# Access Compliance Report

### (Curb Ramps)

Intersection ID: 48198	Main Street: RIVERGATE_PY	Cross Street: S_TRYON_ST	Location: NE
ADA ID: 0122A75C519A	Ramp Type: Perp	Initial Pass/Fail: Fail	Overall Compliance: No
Severity Score: 25			
Codes/Mitigation Info/Possible Solution		Field Measurements/Component Compliance

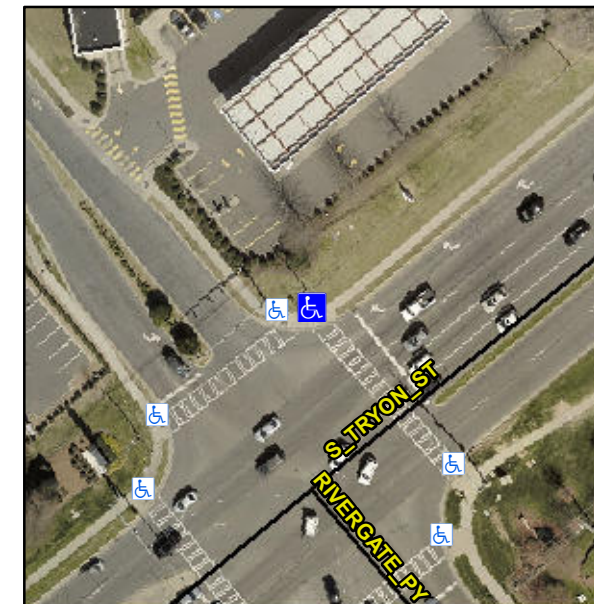
**Remove & Replace Entire Ramp.**

**Not Found, R304.2.2, R304.5.3**

Compliance	Description	Data	Compliance	Description	Data
N/A	Ramp Length (in)	89.0	No	Ramp Slope (%)	8.9
Yes	Ramp Width (in)	48.0	No	Ramp XSlope (%)	5.6
N/A	Flare Type LT	N/A	N/A	Flare Type RT	N/A
N/A	Flare Slope LT (%)	N/A	N/A	Flare Slope RT (%)	N/A
N/A	Flare Traversable LT?	N/A	N/A	Flare Traversable RT?	N/A
N/A	Landing Length (in)	N/A	N/A	DWS Provided?	N/A
N/A	Landing Width (in)	N/A	N/A	DWS Contrast?	N/A
N/A	Landing Slope (%)	N/A	N/A	DWS Length (in)	N/A
N/A	Landing X Slope (%)	N/A	N/A	DWS Full Width?	N/A
N/A	Landing Curb? (Y/N)	N/A	N/A	DWS Offset (in)	N/A
N/A	Shared Landing?	N/A			
N/A	Gutter Ponding?	N/A	N/A	Gutter Slope (%)	N/A
N/A	Gutter Lip Ht (in)	N/A	N/A	Gutter X Slope (%)	N/A
N/A	Painted X Walk1?	Yes	N/A	Painted X Walk2?	N/A
	X Walk 1 Direction	To SE		X Walk 2 Direction	N/A
N/A	X Walk 1 Width (in)	112.0	N/A	X Walk 2 Width (in)	N/A
	X Walk 1 Slope (%)	0.7		X Walk 2 Slope (%)	N/A
	X Walk 1 X Slope (%)	3.3		X Walk 2 X Slope (%)	N/A
